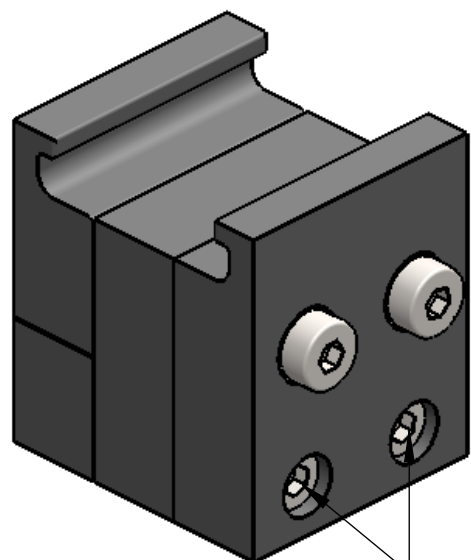
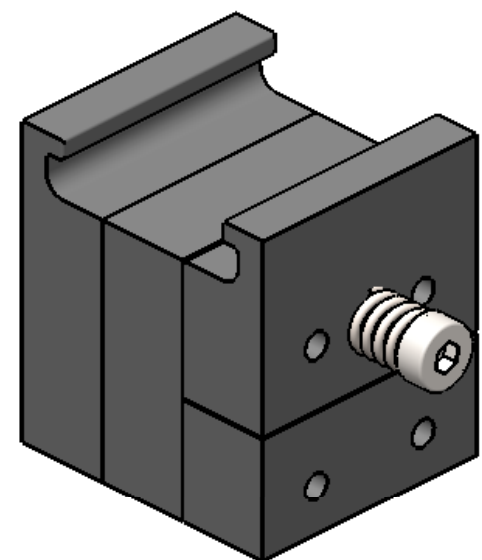
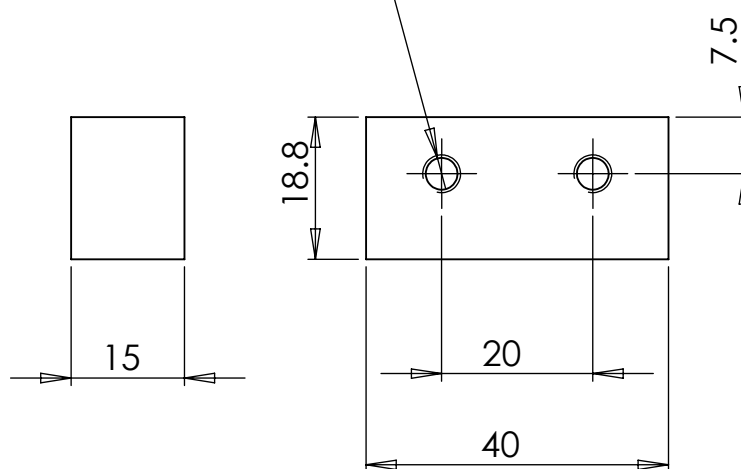
SHOULDER SCREWS COULD BE REPLACED WITH STANDARD  
CAP SCREWS BUT THE TAPPED HOLES WOULD NEED TO BE  
BLIND. ie USING M6 CAP SCREWS THE TAPS WOULD NEED TO BE  
M6x10 Deep SO THEY CAN BE SCREWED INTO A STOP  
ALLOWING THE SPRING TO WORK.
